THE CITY OF SAN DIEGO

ENVIRONMENTAL IMPACT REPORT

Project No. 360009
SCH No. 2014071065

SUBJECT: MERGE 56 (AKA MERGE 56 DEVELOPMENT PROJECT): The project is comprised of two project components, a mixed-use development and public roadway improvements. The Mixed Use Development Component would require a GENERAL PLAN AMENDMENT from Commercial Employment, Retail and Services; Residential; and Parks, Open Space and Recreation to Multiple Use; a COMMUNITY PLAN AMENDMENT (CPA) to redesignate the site from Commercial Regional (CR) and Medium High Density Residential to Local Mixed Use (LMXU) within the Torrey Highlands Subarea Plan; a REZONE from Regional Commercial (CR-2-1) and Multi-family Residential (RM-3-9) to Community Commercial (CC-3-5) and Residential Small Lot (RX-1-2); a PLANNED DEVELOPMENT PERMIT (PDP) to amend PDP No. 53203; a SITE DEVELOPMENT PERMIT (SDP) to amend SDP No. 53204; a CONDITIONAL USE PERMIT (CUP) to allow a cinema/theater greater than 5,000 square feet in size; and a VESTING TENTATIVE MAP (VTM) to amend VTM No. 7938 to resubdivide from 3 lots to ~~400~~ 107 lots (84 Residential Small Lot zoned lots, ~~seven~~ 12 Community Commercial zoned lots, ~~five~~ seven

Figure 2-3

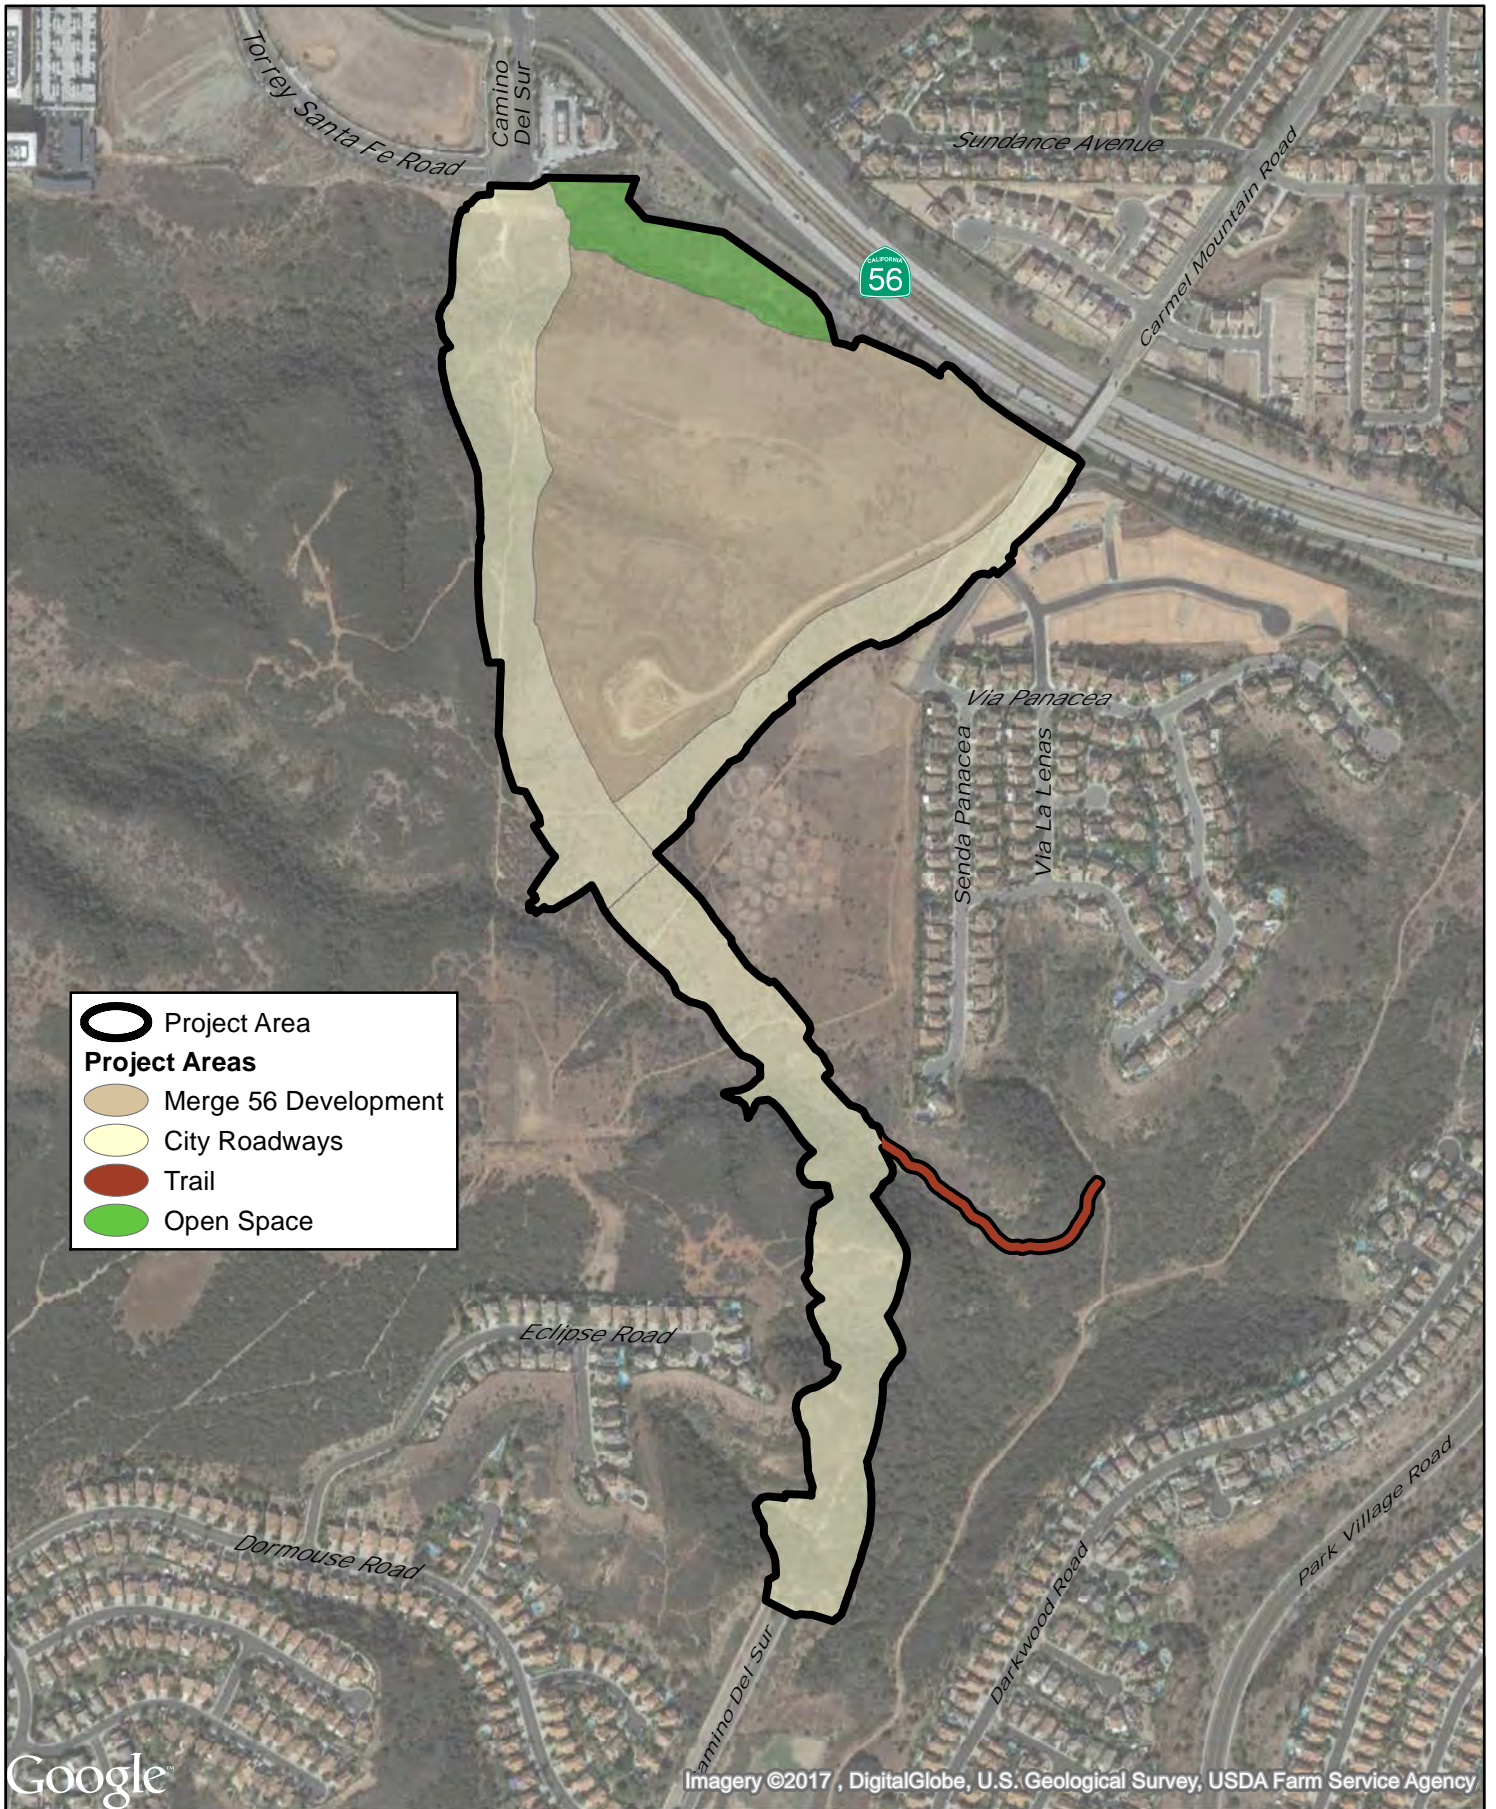
7. Figures 2-2, 2-3, 2-6, and 3-1: These figures inaccurately indicate that the project area extends onto Refuge land. As discussed above, all direct impacts to Refuge lands during and following construction of the proposed development shall be avoided. In addition, Figures 2-6 and 3-1 incorrectly identify the area within the MHPA as “proposed MSCP preserve.” These figures should be revised to indicate that the majority of the lands shown in green are already part of the MHPA.

- B10** The text referenced in this comment is introductory and supplemented by more detailed information on ownership within Del Mar Mesa MHPA contained in Draft EIR Section 2.4.7, Carmel Mountain and Del Mar Mesa Natural Resource Management Plan. The information about the nature of surrounding properties that is requested in the comment has been integrated into Section 2.2 of the Final EIR. The MHPA and Refuge boundaries were shown in Figure 5.3-1a of the Draft EIR. The boundaries of the Refuge lands have also been added to Figure 2-2 in the Final EIR.

- B11** The figures referenced in the comment are more general in nature and intended solely to depict the project area boundary studied in the EIR or existing and proposed land use designations. Those figures are not intended to represent the limits of grading or biological resource impacts associated with the project. Figure 5.3-1a in the Draft EIR's Biological Resource section shows that although the Refuge is contained in the study area, no impacts are proposed. Please refer to responses B3 and B5 that describe the avoidance measures that would prevent impacts to the Refuge. The purpose of the land use figures (i.e., Figures 2-6 and 3-1) are to illustrate the existing and proposed land use designations for the project site based on the Torrey Highlands Subarea Plan. The terminology "proposed MSCP Preserve" is taken from the Torrey Highlands Subarea Plan, which was adopted before the Refuge was established. Figures 2-6 and 3-1 have been updated in the Final EIR to clarify the status of the adjacent open space lands.

Figure 2-5

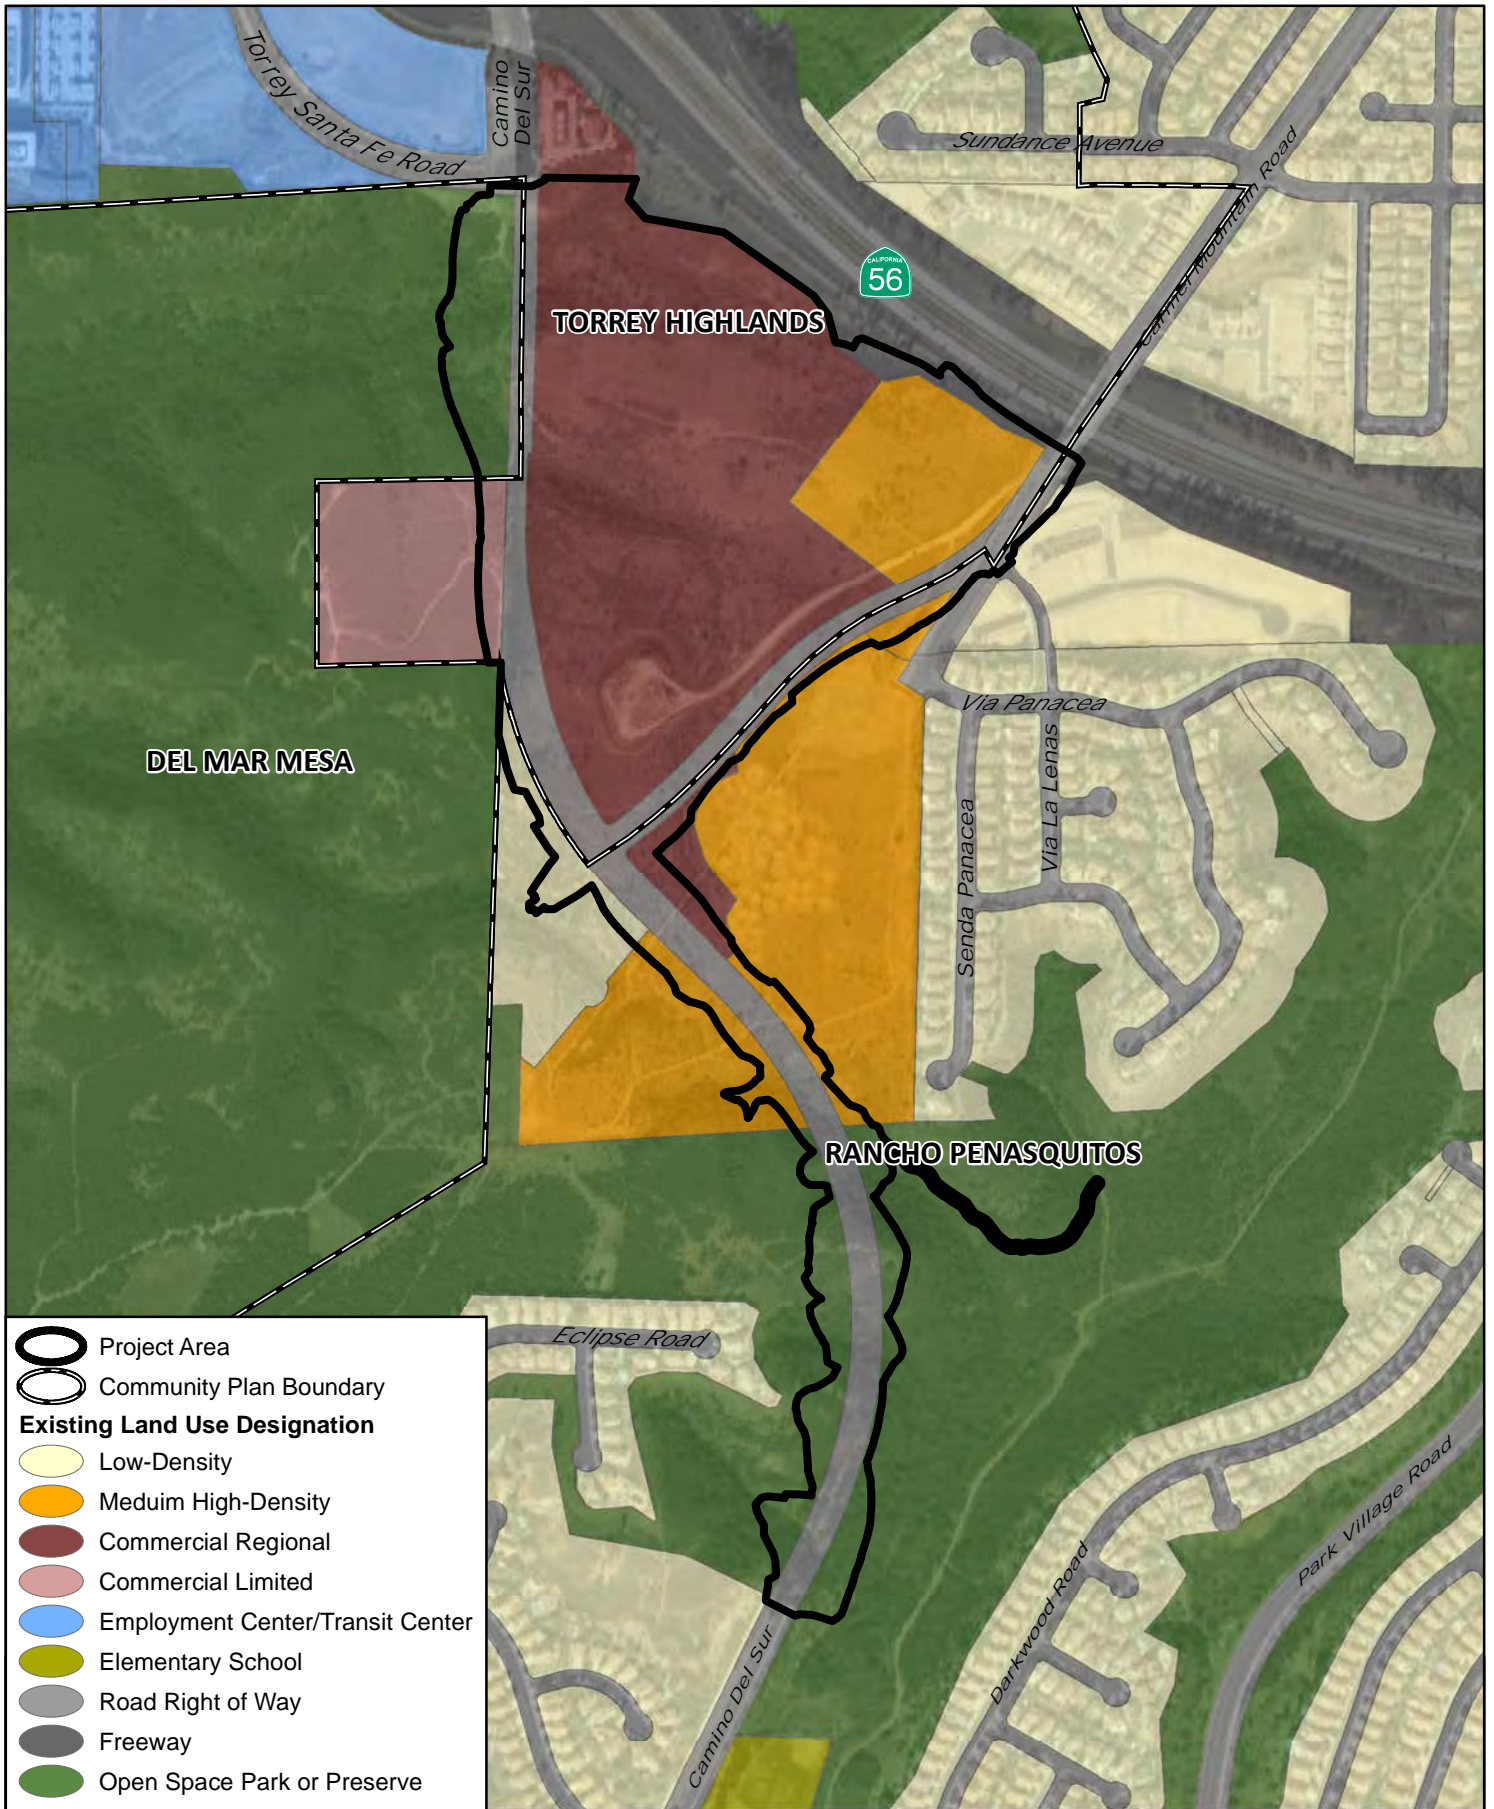
- N5 5. Figure 2-5, Existing Conditions, shows easements across Rhodes Crossing that have been vacated. We request that this be corrected.
- Additionally, based on the number of multi-family dwelling units entitled on Lot 3 of the Rhodes Crossing VTM, the Merge 56 CPA taking Camino del Sur from 4 lanes to 2 lanes, and in conversations with the applicant, they are amenable to providing a deceleration lane into Lot 3 of Rhodes Crossing, as well as notes on the Merge 56 Plan Set that clearly denote that the Rhodes Crossing VTM has assured traffic signals, per the approved VTM and associated Conditions, into Lots 2 and 3 of Rhodes Crossing. We would comment that those are not yet shown on the Existing Conditions exhibit for the Merge 56 DEIR.

- N5 The purpose of Figure 2-5 is to depict current conditions and topography on the project site only, not the location of easements on off-site property that have no bearing on the CEQA analysis. Nonetheless, the easement lines noted in this comment have been removed from the VTM by the project engineer; see the revised Figure 3-12 in the Final EIR. These revisions do not alter the analysis or conclusions disclosed in the Draft EIR.

Figure 3-2

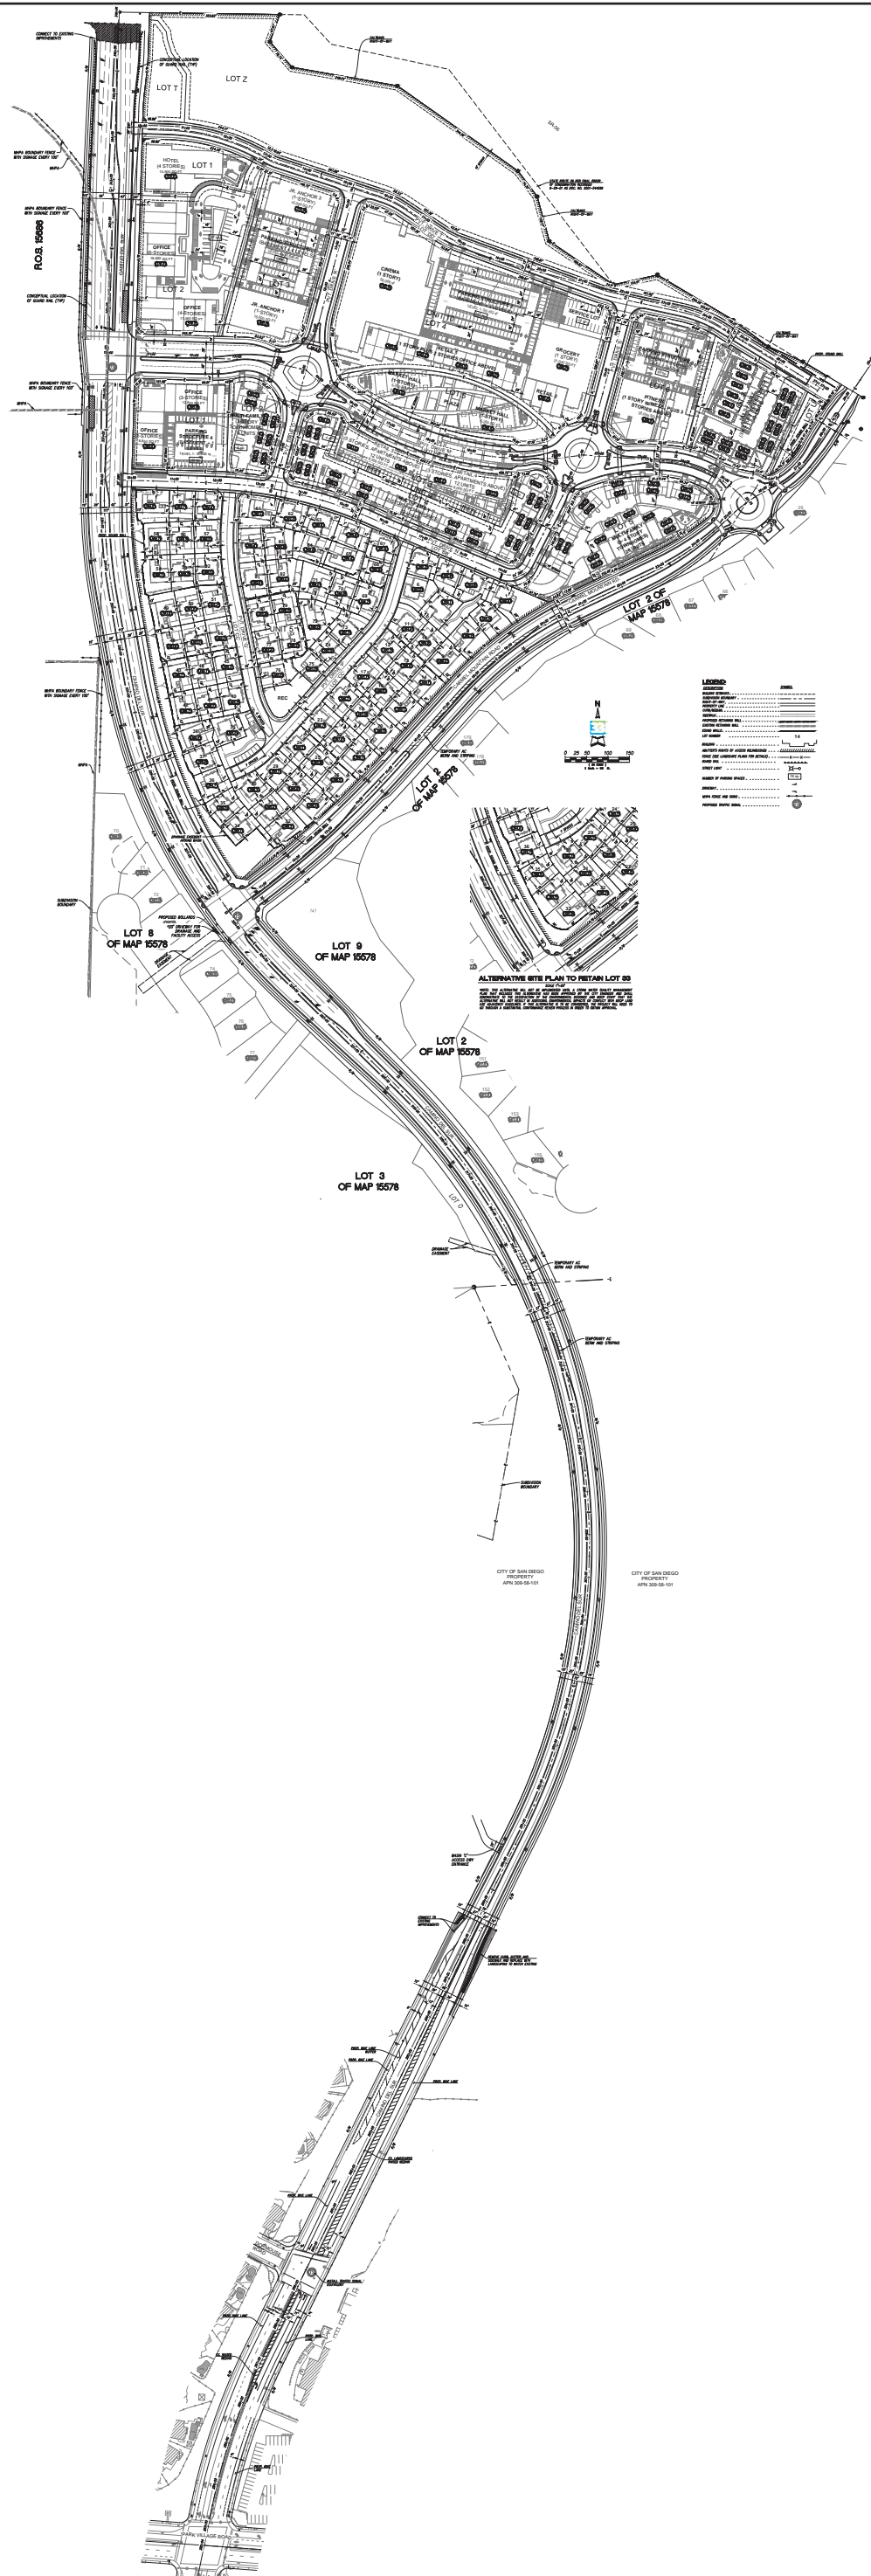
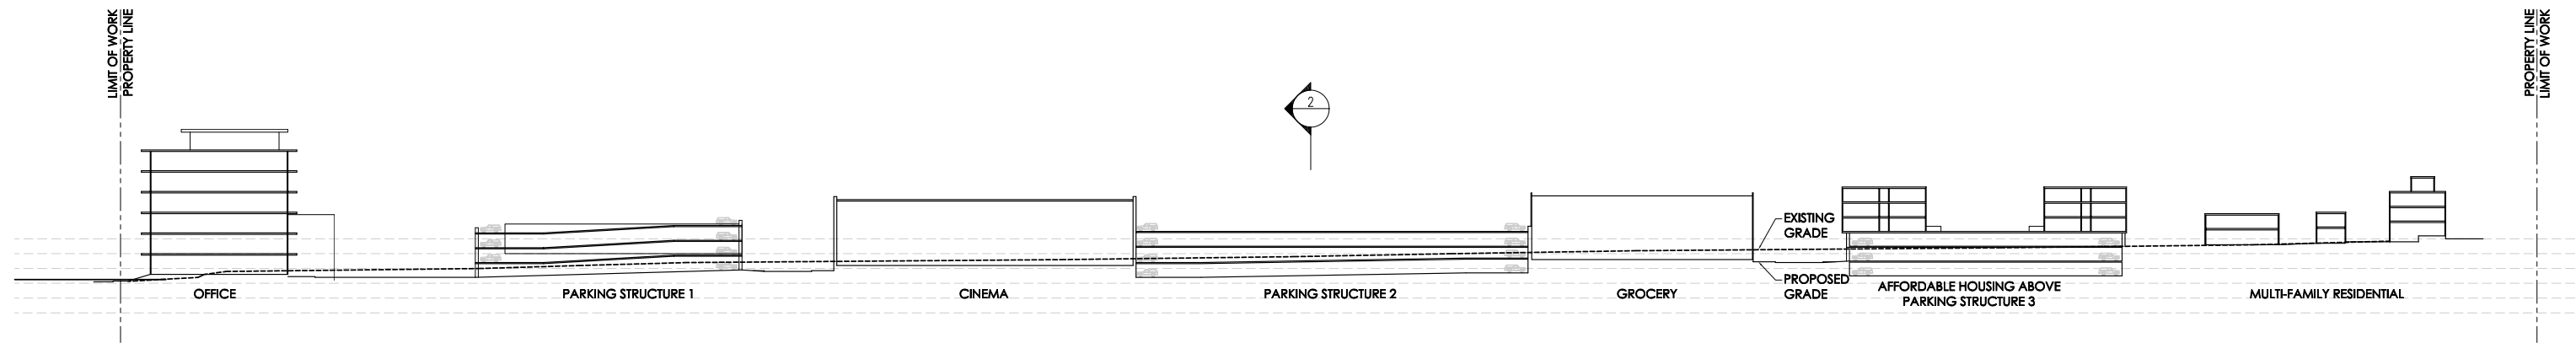
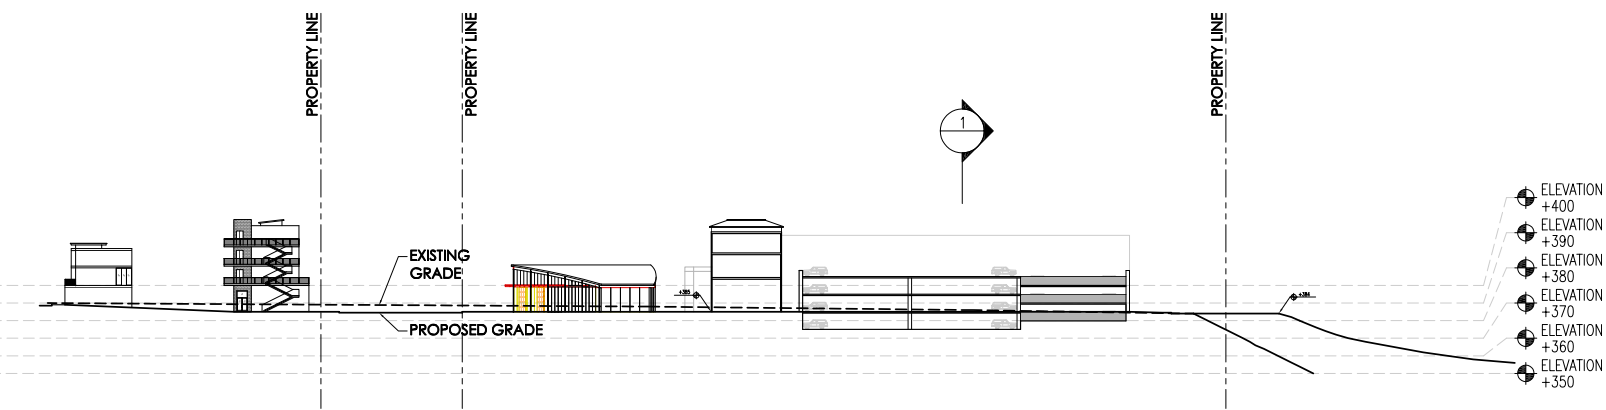
- N1 [1. Figure 3-2, Proposed Zoning, inaccurately represents the existing zoning for of the remaining Rhodes Crossing VTM parcels. We request this be corrected per Rezone Ordinance No. O-19273 adopted on April 12, 2004 for the Rhodes Crossing Project.
- N2 [2. Figures 2-2 and 3-3 appear to inaccurately depict how the MHPA line abuts Rhodes Crossing Lot 8. Although it is difficult to tell without a direct CAD overlay of Figures 2-2 and 3-3 onto the Rhodes Crossing VTM, the MHPA line depicted in them appears to overlap onto the Rhodes Crossing Lot 8 development area. We request that this be reviewed by the City and corrected as appropriate.
- N3 [3. Figure 5.3-3 shows the Darkwood Canyon to Del Mar Mesa Wildlife Corridor cutting through Rhodes Crossing development Lots 3 and 8. This needs to be corrected. This wildlife

- N1 The purpose of Figure 3-2 is to show the proposed zoning for the Merge 56 project site; modifications to the figure to adjust/update zoning on off-site parcels are not required by CEQA.
